**COCONUT POINT MPD/DRI (Tract 1D-3)**  
**Mixed Use Planned Development Amendment**  
**Zoning Staff Report**

**PROJECT NAME:** HILTON GARDEN INN ON TRACT 1D-3  
**CASE TYPE:** PLANNED DEVELOPMENT AMENDMENT  
**CASE NUMBER:** DCI2017 - E003  
**PLANNING & ZONING BOARD DATE:** March 20, 2018  
**COUNCIL 1<sup>ST</sup> READING:** TBD

COCONUT POINT  
TRACT ID-3  
PROJECT NUMBER: 1703  
SCALE: AS SHOWN  
CONCEPT PLAN

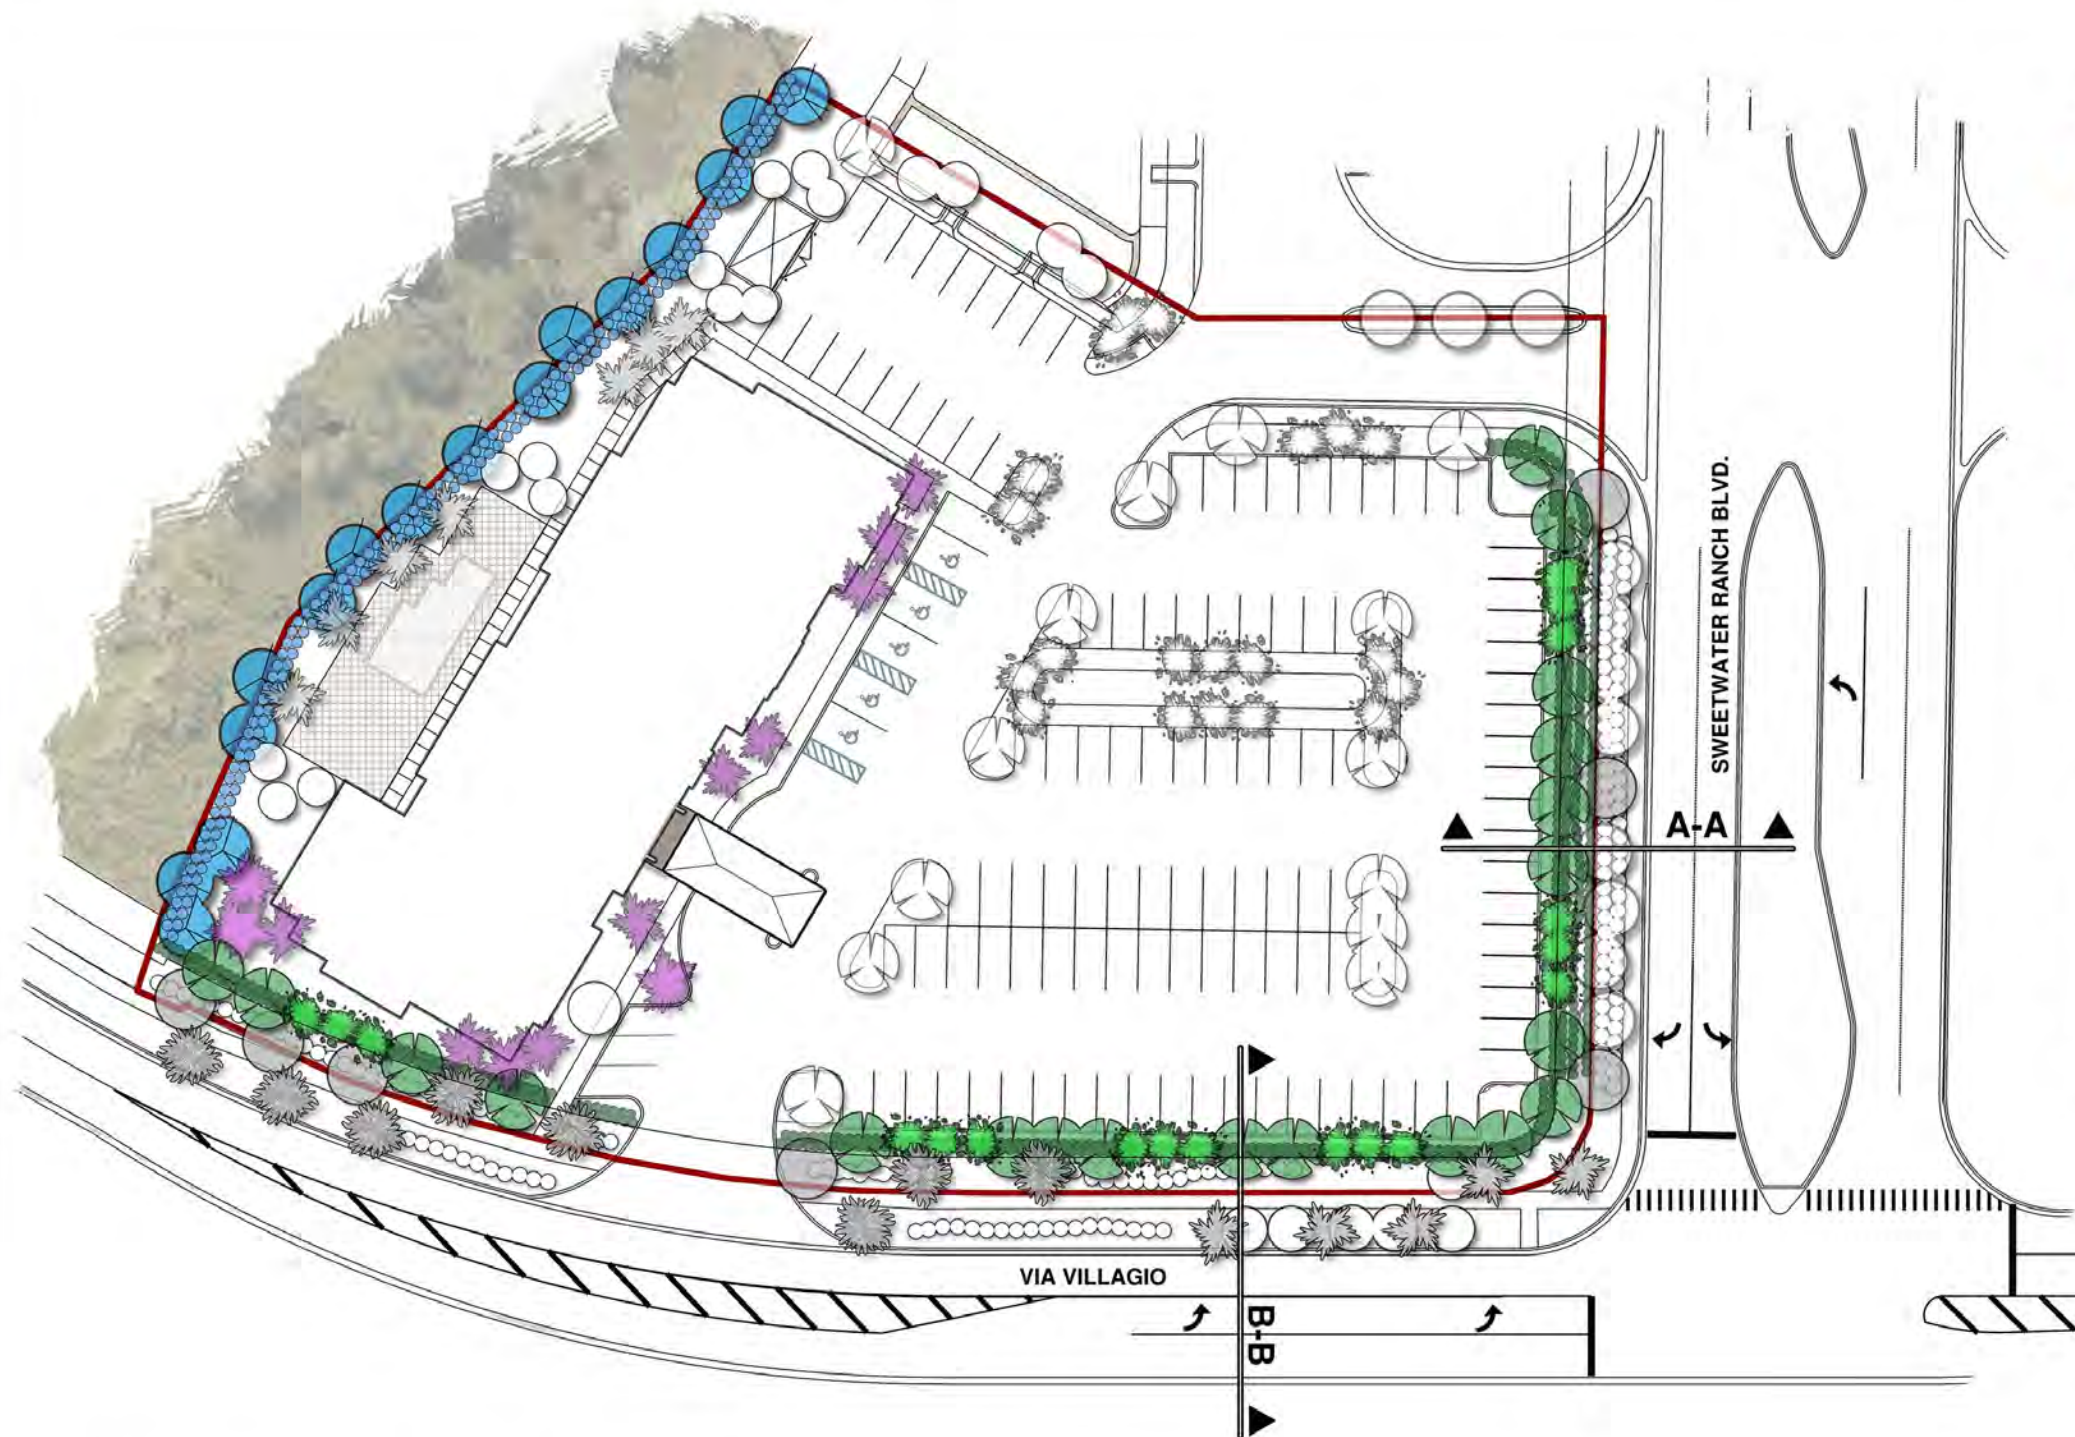
The site plan proposes ingress and egress to the proposed hotel from Sweetwater Ranch Boulevard off US 41, utilizing an existing, shared access with the fire station, and from Via Villagio. There are existing sidewalks, part of the overall Coconut Point pedestrian system, along both Sweetwater Ranch Boulevard and Via Villagio. This amendment includes deviations that will be discussed later in the staff report.

5,000 square feet of retail, 35,000 square feet of office, and the fire station. Ingress and egress to the proposed hotel will be from Sweetwater Ranch Boulevard, utilizing an existing, shared access with the fire station, and from Via Villagio. A proposed location for an off-site parking area, to be utilized by employees of the hotel, was identified across Sweetwater Ranch Boulevard on Tract 1C. This off-site parking area will provide up to 10 parking spaces and will be accessed by way of easement to be provided at the time of Development Order. There are existing sidewalks along Via Villagio and the south side of Sweetwater Ranch Boulevard. Staff believes that a condition should be included in any approval of the hotel use on Tract 1D-3 that a sidewalk connection, including the provision of crosswalks, be provided from the off-site parking area to the hotel.

# Building Elevation

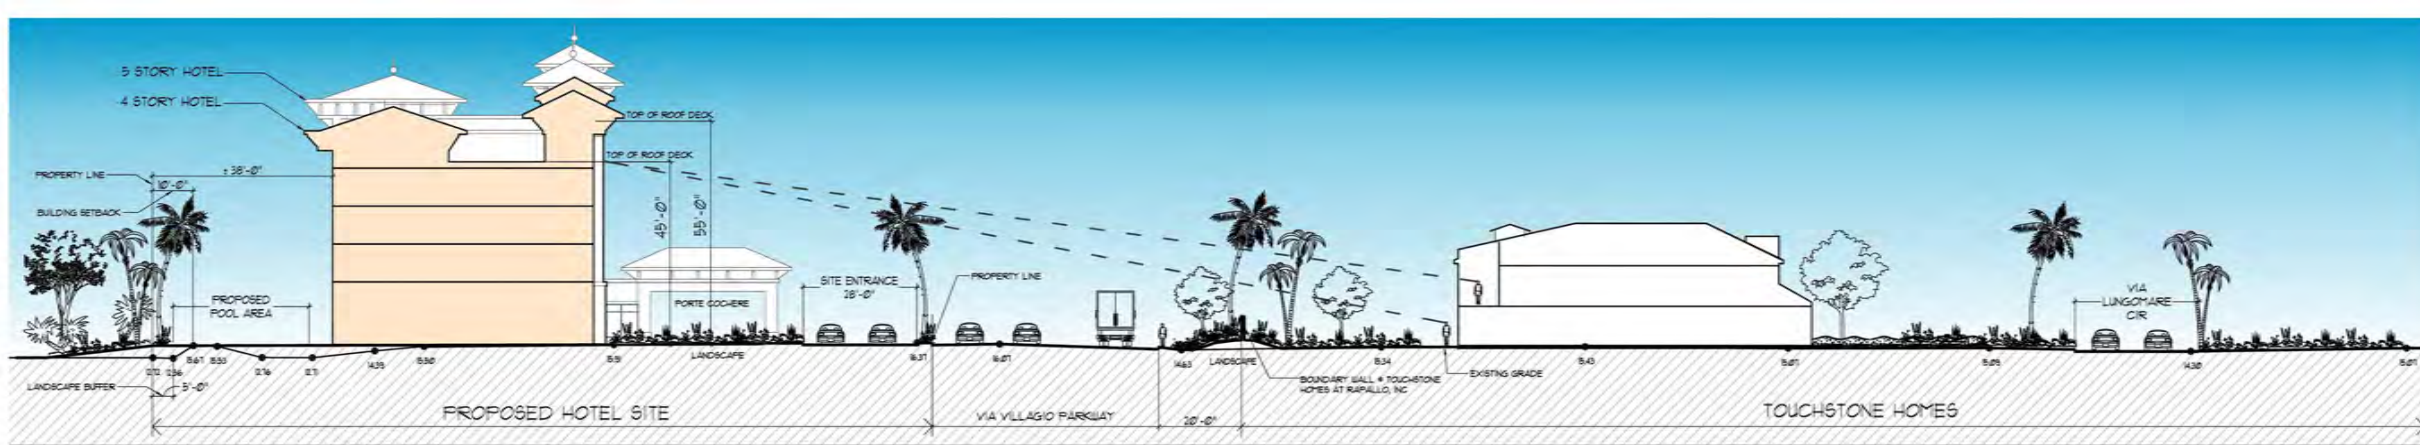
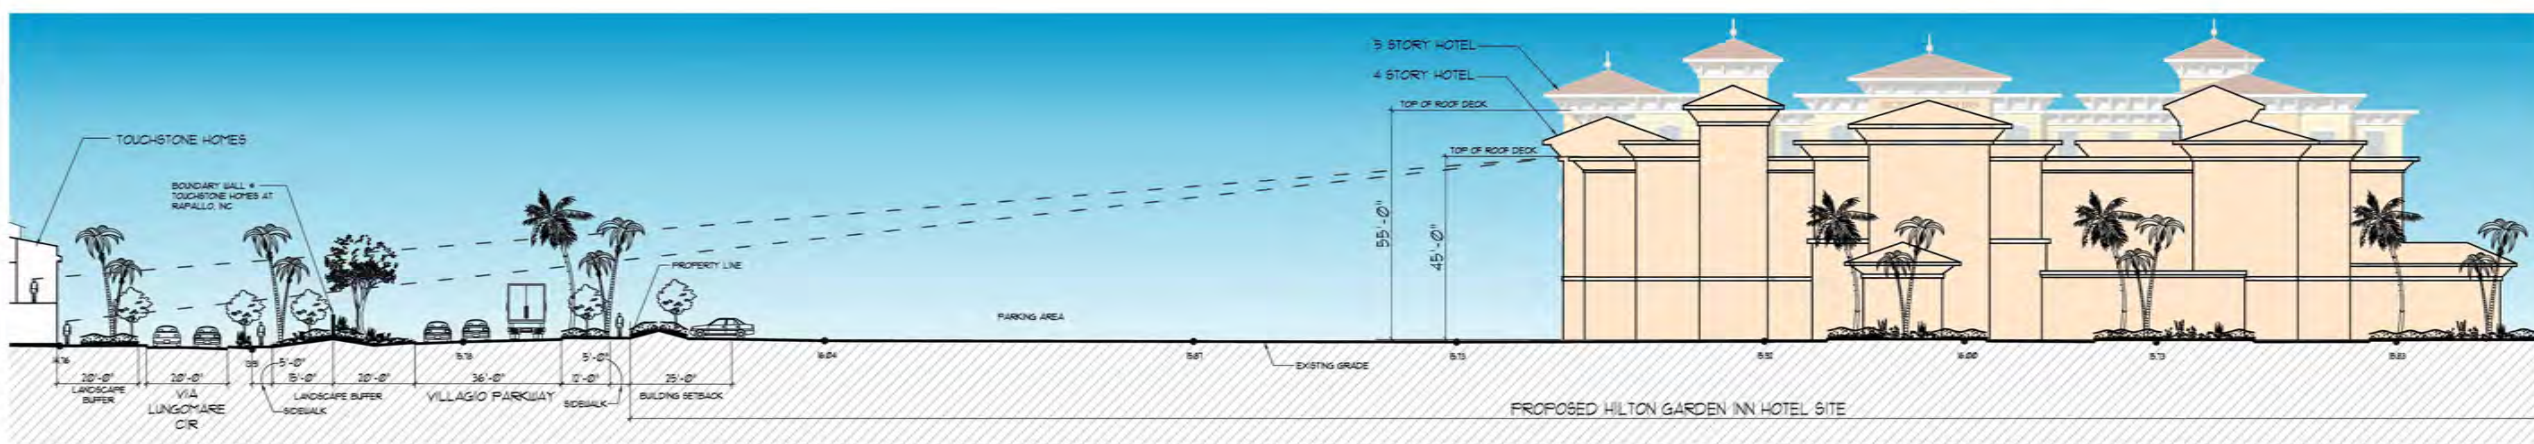
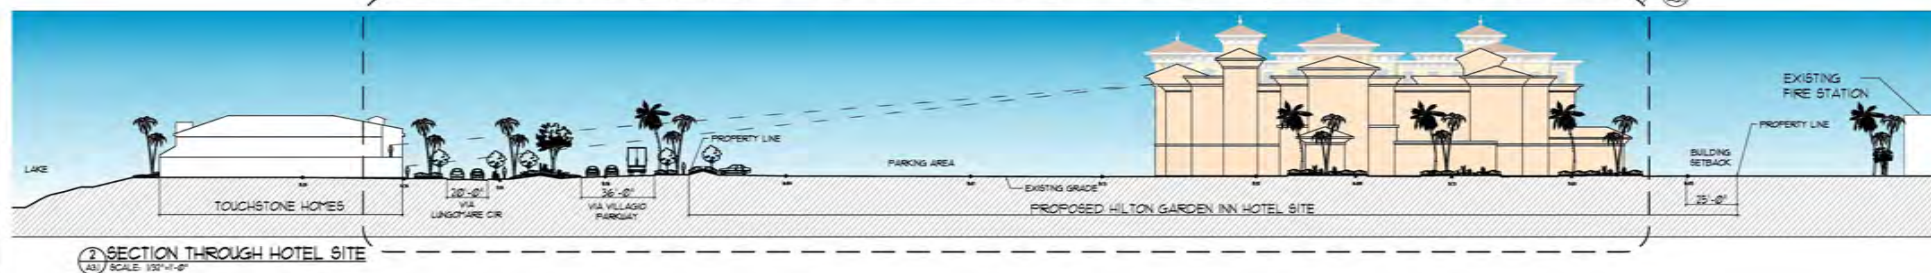
The architectural treatment of the proposed hotel is shown to be Mediterranean, as depicted on the conceptual elevation, which is a consistent “theme” within Coconut Point and also consistent with the Coconut Point Design Guidelines. A recent addition to the Pattern Book is a new color scheme option. The initial submittal included one color scheme, with shades of yellow, similar to the style of Rapallo. The new color scheme (option 1) appears to be white and grey shades.

The Pattern Book only shows one elevation for the architecture, the front of the building. The staff requested elevations for the remaining sides but the applicant decided not to provide these.

DEVIATION 1 & 2  
BUILDING HEIGHT

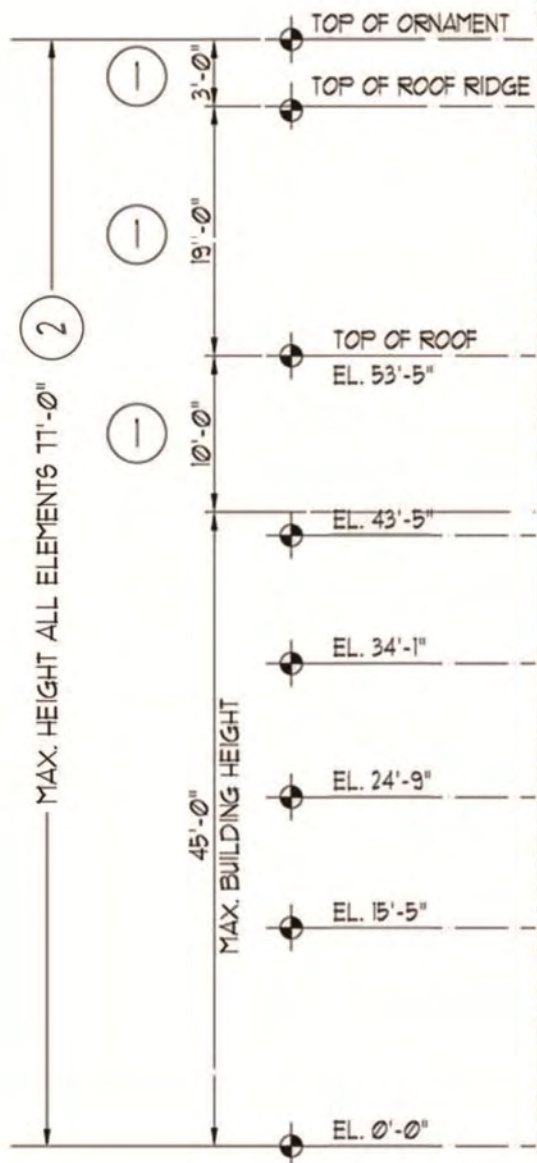
Section 33-229 of the Land Development Code limits height of buildings outside of the Highway Interchange Areas to a maximum of three stories or 45 feet, whichever is less. This section of the code also provides that "Elements that enhance visibility, create focal points or amenities, such as turrets, sculpture, clock tower and corner accentuating rooflines, may exceed the maximum height limitations with an approved variance or deviation. The applicant requests an increase in the allowable height for Tract 1D-3 to 55 feet or three stories, and 77 feet for the architectural features. A Line of Sight Diagram has been provided to illustrate the view from Rapallo. It appears that the top floor of the hotel will be visible from some Rapallo residences.

**Deviation 1** is from the LDC Section 33-229, “Maximum Height,” which limits maximum building height outside of the Interstate Highway Interchange Areas to a maximum of three (3) stories or 45-feet, to allow a maximum building height of 55 feet, as measured in accordance with LDC Section 34-2171(1).

**Deviation 2** is from LDC Section 33-229, “Maximum Height,” which requires a deviation to exceed the maximum height limitations for architectural elements that enhance visibility or create focal points or amenities, such as turrets, sculpture, clock tower, and corner accentuating rooflines, to allow for architectural elements not to exceed an additional 22 feet in height for a maximum architecture feature height of 77 feet as depicted in the Pattern Book.
